Item #1:
Report Of The June 26, 2103 AC Meeting

MEMORANDUM

TO: Village President and Village Board
FROM: James M. Hogue, Village Planner
DATE: July 2, 2013
RE: Board & Commissions Report for 7/9/13

AC: 6.26.13 Rescheduled Regular Meeting (4 action items)

Beth Judea Exterior Sign Proposal

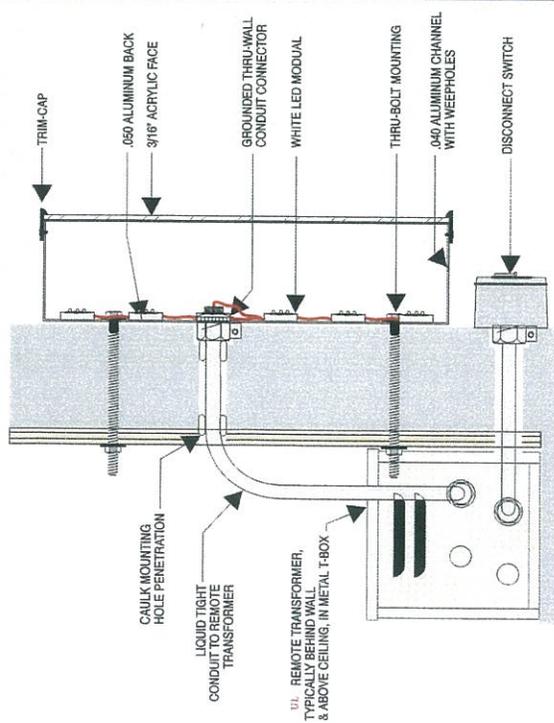
The AC liked the look of the new sign noting it was an improvement to the existing sign.

A motion was made by Commissioner Styer, seconded by Commissioner Howard, to recommend approval of the signage as submitted. On a voice vote; all aye.

Custom Exterior Sign
WALL FRONT SIGN

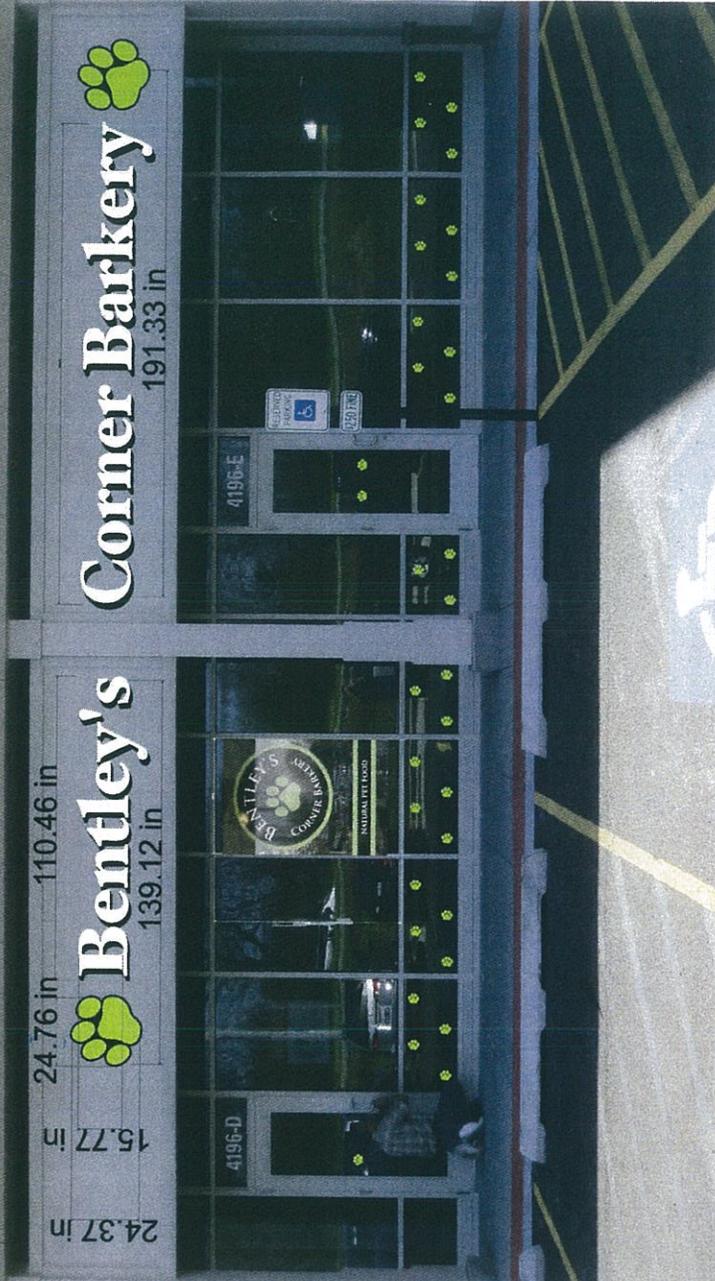
The AC reviewed the sign specifications and were favorable to the appearance of the sign. The AC did request that the sign be “tightened up” across both suites to create the appearance of one single sign across the building façade. The petitioner was amenable to this suggestion.

A motion was made by Commissioner Calas, seconded by Commissioner Plunkett to accept the sign as submitted subject to the petitioner “tightening up” the sign across the building façade to create the appearance of a single sign on the structure. On a voice vote; all aye.

AREA LIGHTS RXA-01 SERIES

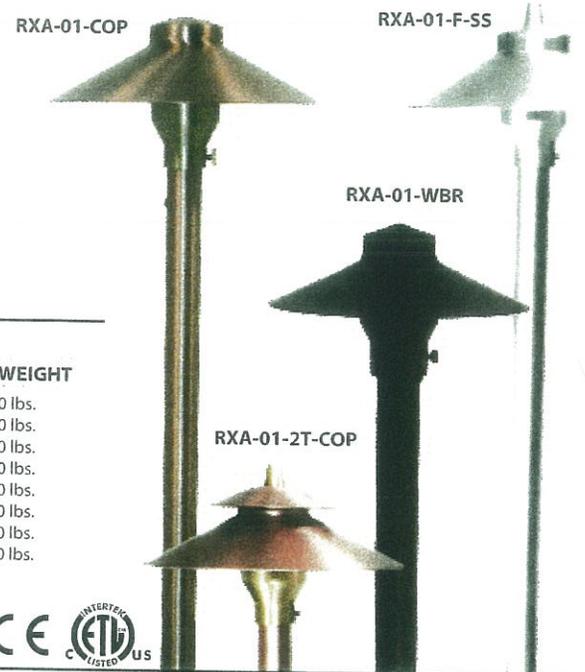
The pathway lighting and wall lighting are considered “residential yard and grounds lighting” and is permitted without AC review. The directional fixtures, up-lighting the trees, are considered landscape lighting and require AC review and approval. Planner Hogue indicated the likely rationale for the distinction and review of the landscape lighting was to prevent “leakage” or glare from such lighting spilling onto neighboring properties. As grounds lighting is lower to the ground and designed to illuminate pathway and walkways on property, leakage is less likely to be an issue. As landscape lighting is often “up lighting” of various landscape elements on a property a greater potential for “leakage” exists.

He further indicated that in this instance an LED light source has been identified and should be approved as an “Other” light source by the AC. Aside from this, the other lighting “test” criteria appear to have been met. “Spillage” of light on adjacent properties should not be an issue with this request as lighting will be near and aimed toward the principal structure. Fixtures are “dark sky” compliant based on photometric specs submitted with the fixtures and a distance of 80 to 120 feet from structures on adjacent properties.

A motion was made by Commissioner Howard, seconded by Commissioner Calas to accept the request for landscape lighting on property located at 4983 Trillium Trail within the Prairie Trails Subdivision as submitted including the LED light source. On a voice vote; all aye.

DIRECTIONAL LIGHTS RXD-02 SERIES

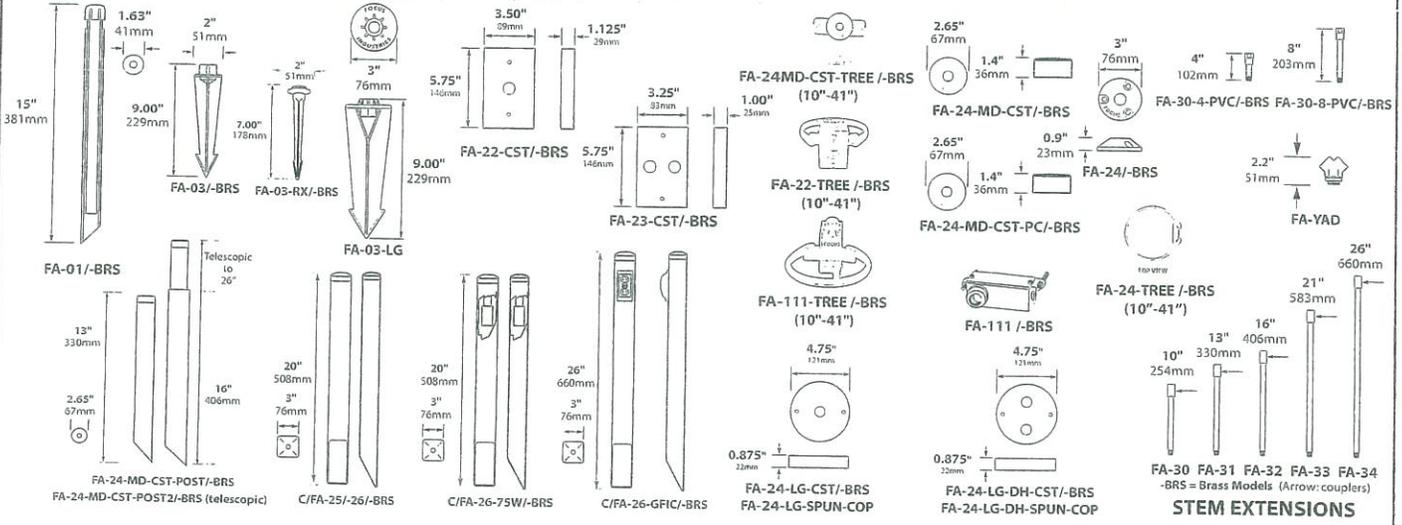
The AC concurred with the findings of Planner Hogue and further indicated the low wattage of the proposed lighting should also serve to mitigate the leakage issue.
